Memorandum

SUBJECT: **REGULATING PLAN WITH MAJOR WARRANTS FOR A DRIV-THRU RESTAURANT**

BACKGROUND: This is a request for approval of a regulating plan (concept plan) with major warrants for the proposed development of a restaurant with a drive-thru. The 1.3-acre site is generally located on the north side of Stacy Road, west of Highway 5 and is zoned for the (CPDD) Commercial Planned Development District with the Urban Village Sub-district. Applicant: Karis Smith with Jones & Carter, representing Village FV LTD.

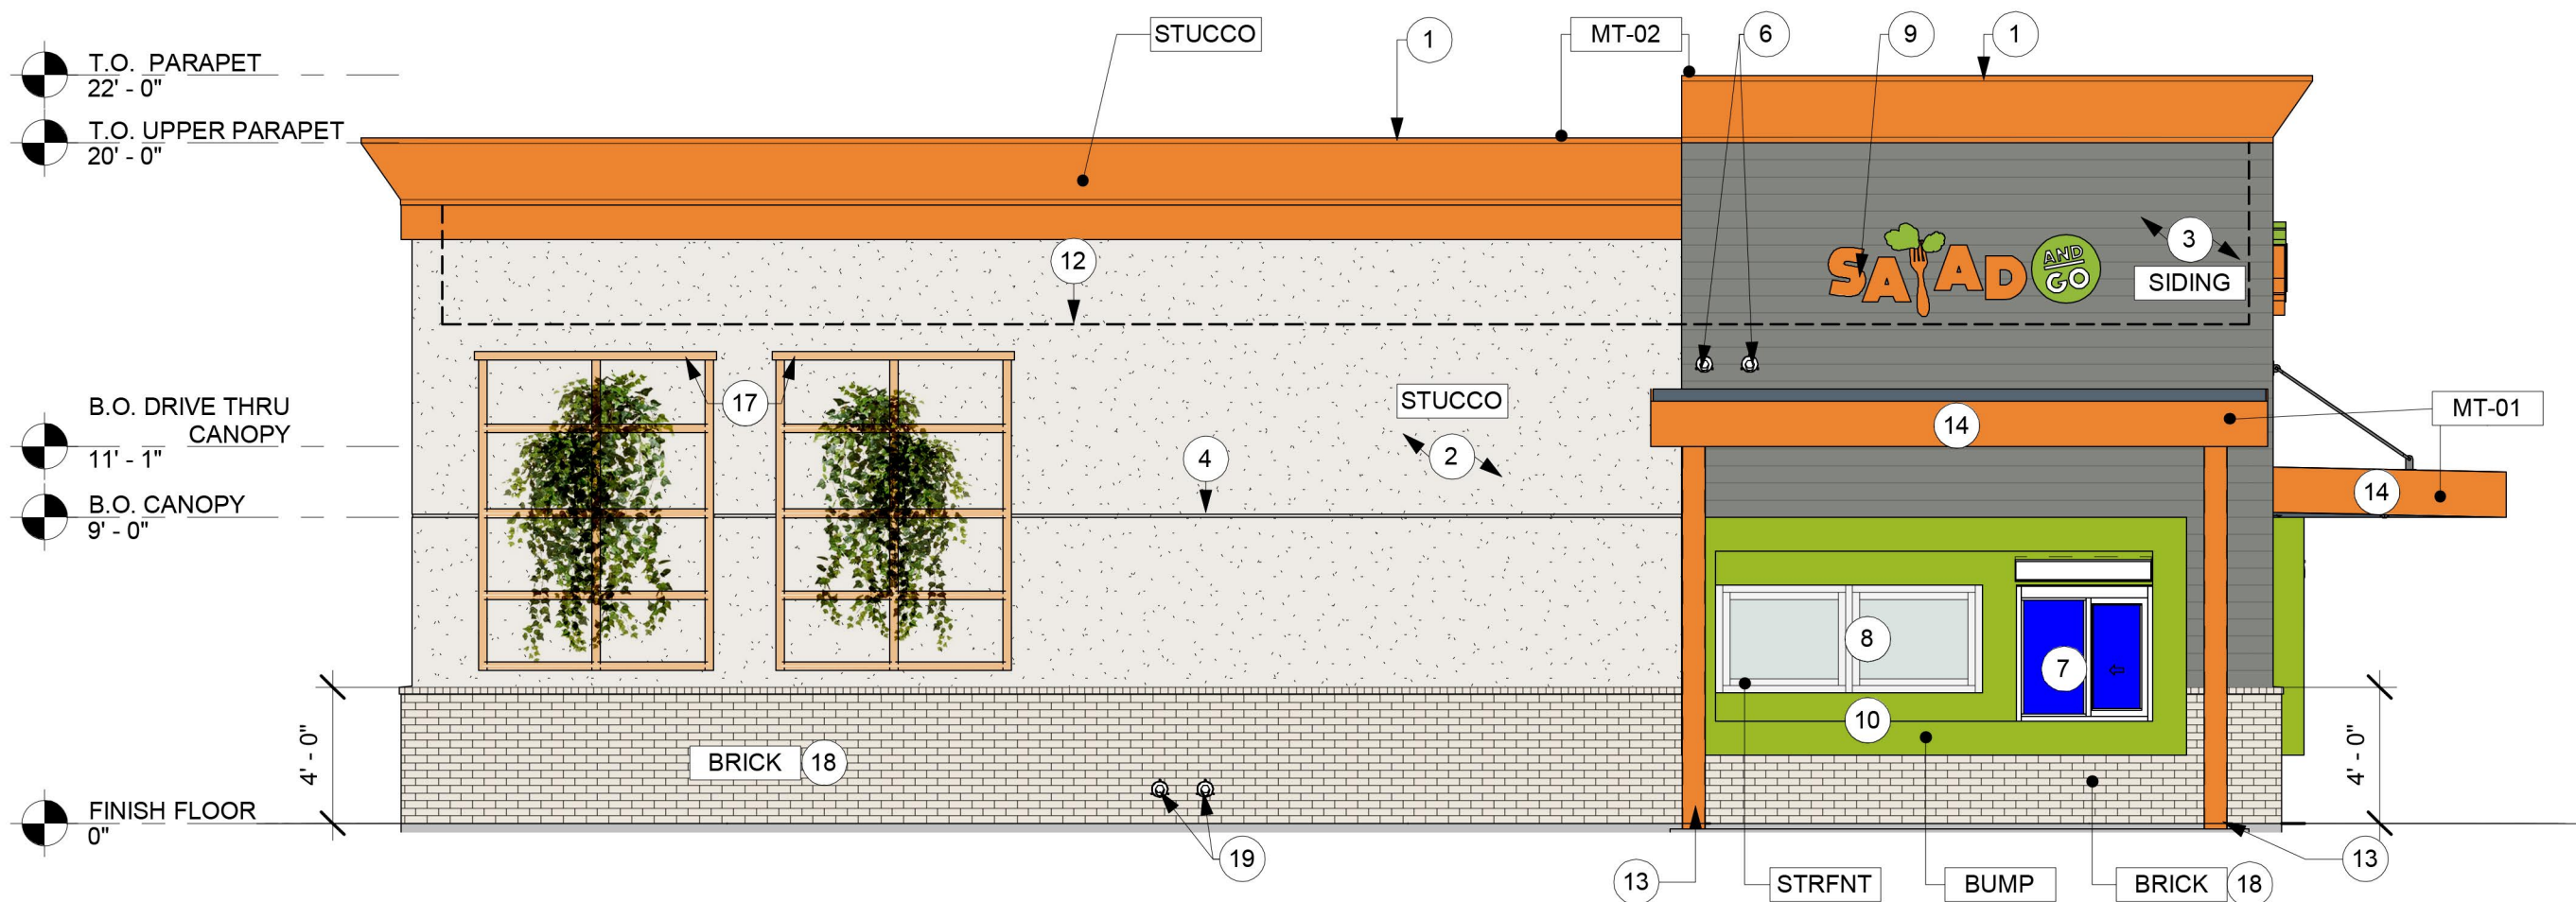
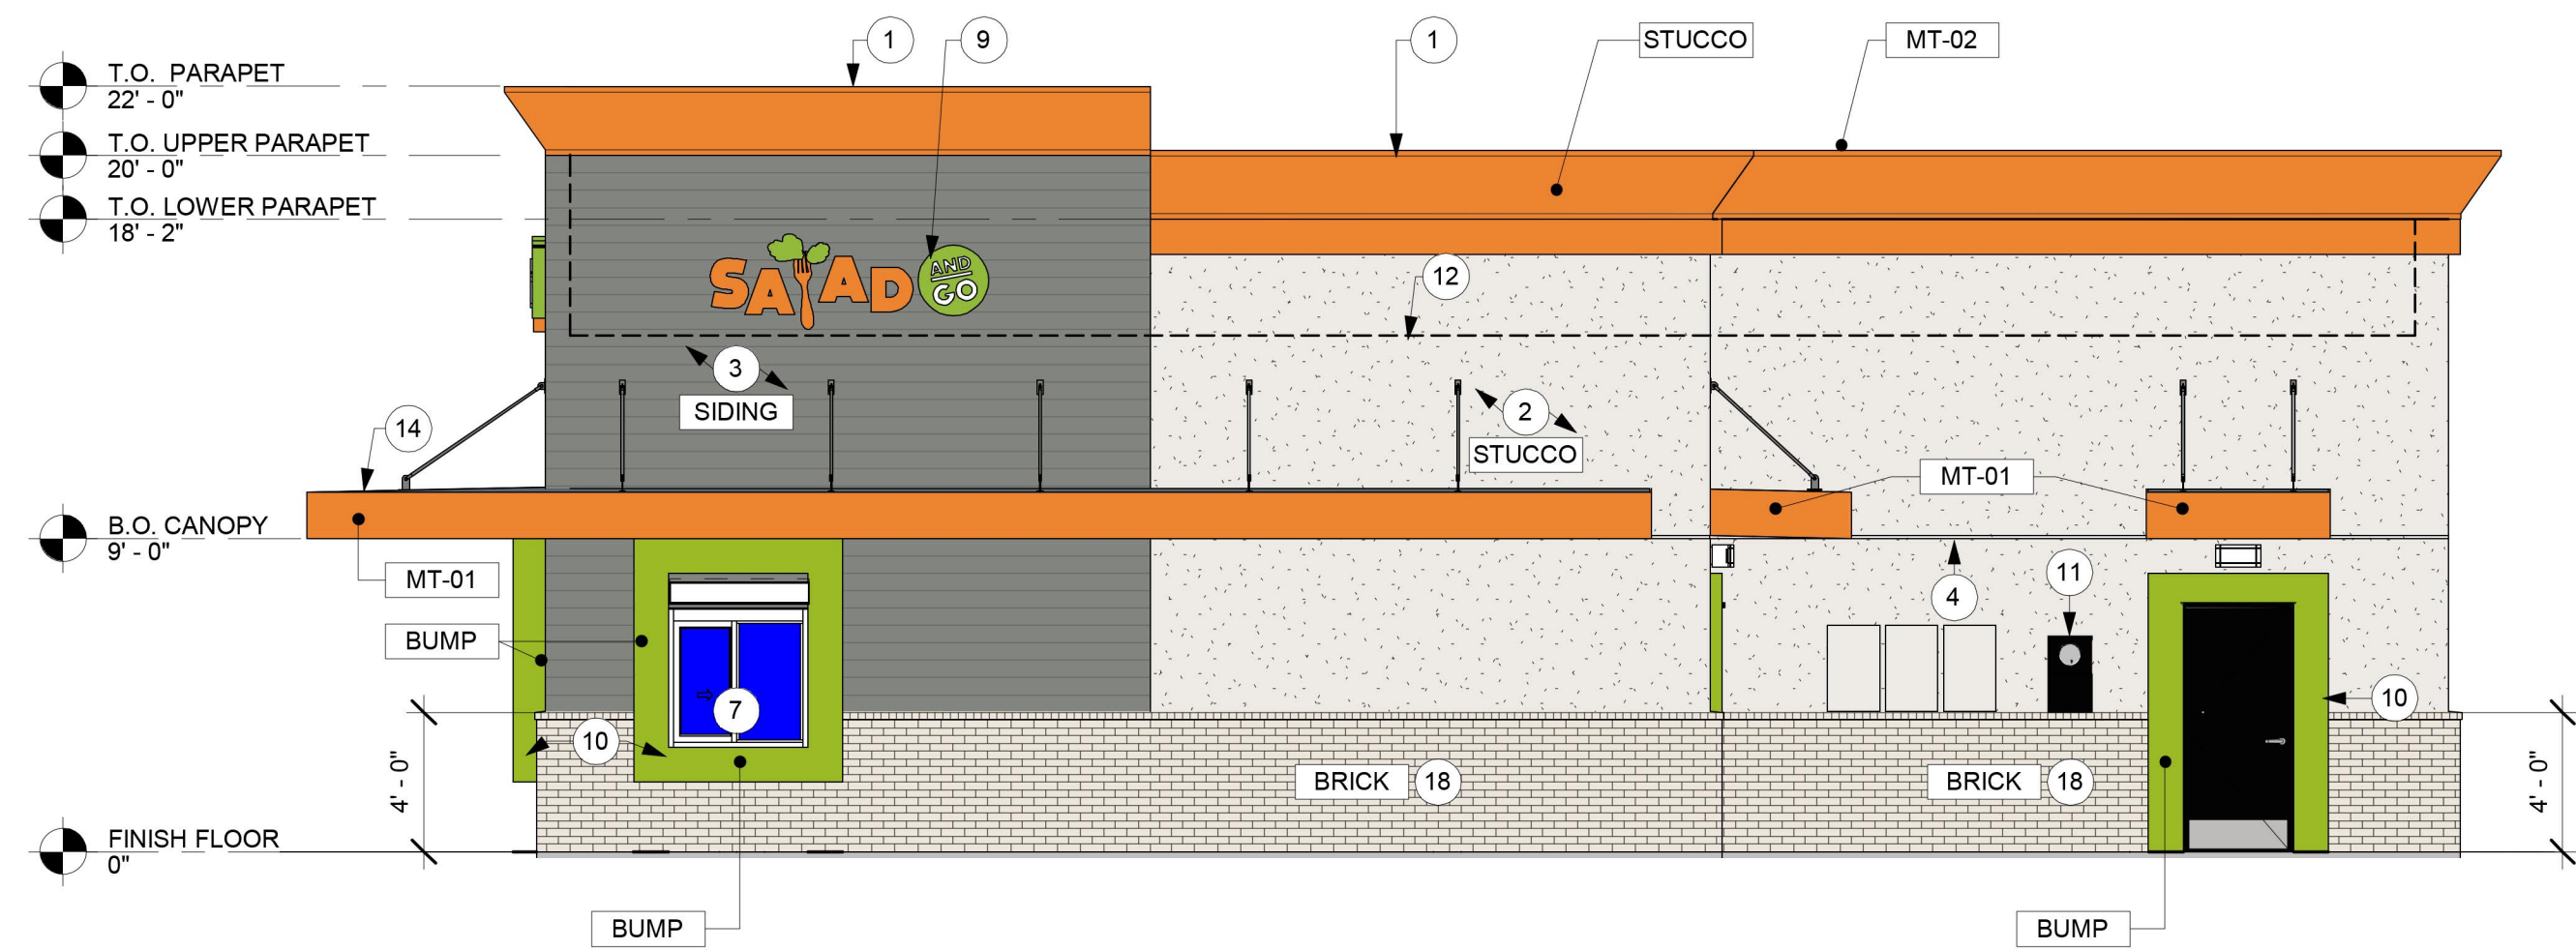
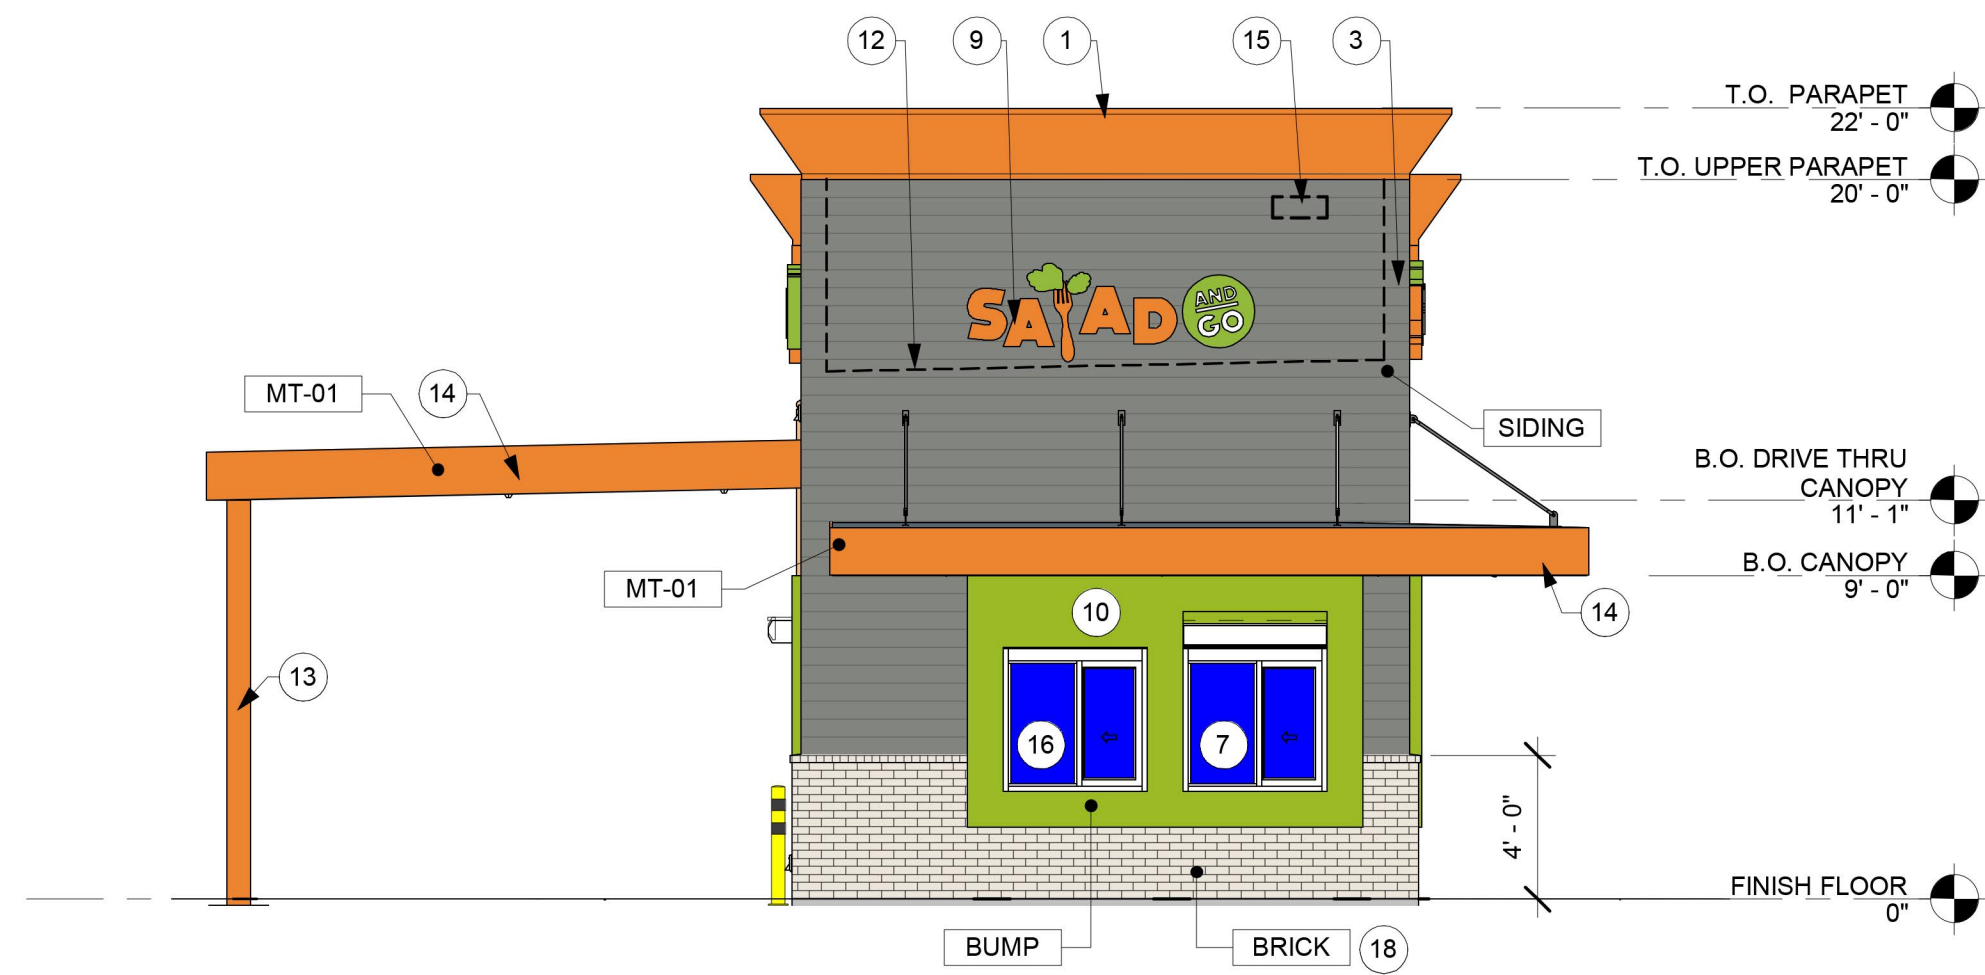
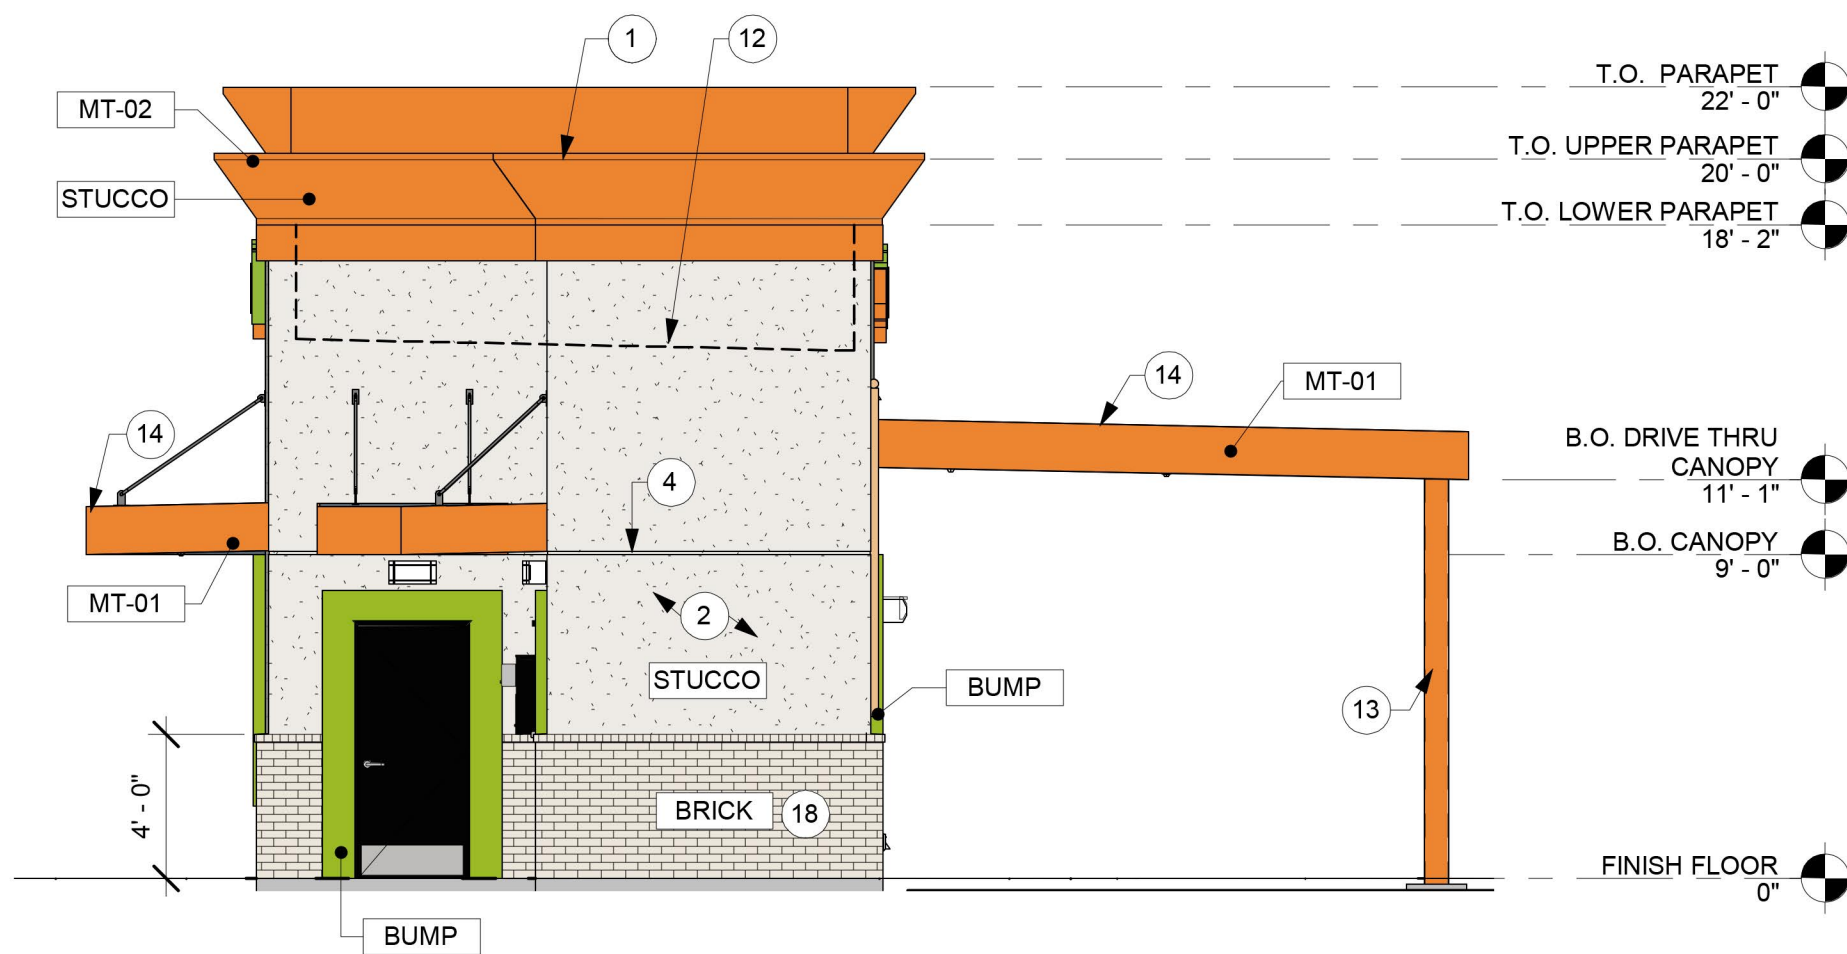
Window Percentage	60% - 80%	East - 1% West - 4% North - 0% South - 9%	The current requirement dictates windows should account for 60-80% of the façade on each side of the building. However, a warrant is being requested due to the type of development being proposed and the building use. As the business type is a drive-thru, the windows would not create an additional draw to the business or provide a more inviting atmosphere as the customer would merely see the inside of a food preparation area. The additional windows would also create difficulty for placement of the equipment required for operations.
	Canopy	Min. 75%	East - 67% West - 32% North - 36%	A warrant is being requested due to the type of development being proposed and the building use. Any of the sidewalk areas adjacent to the building that employees or customers would use are covered by proposed canopies.
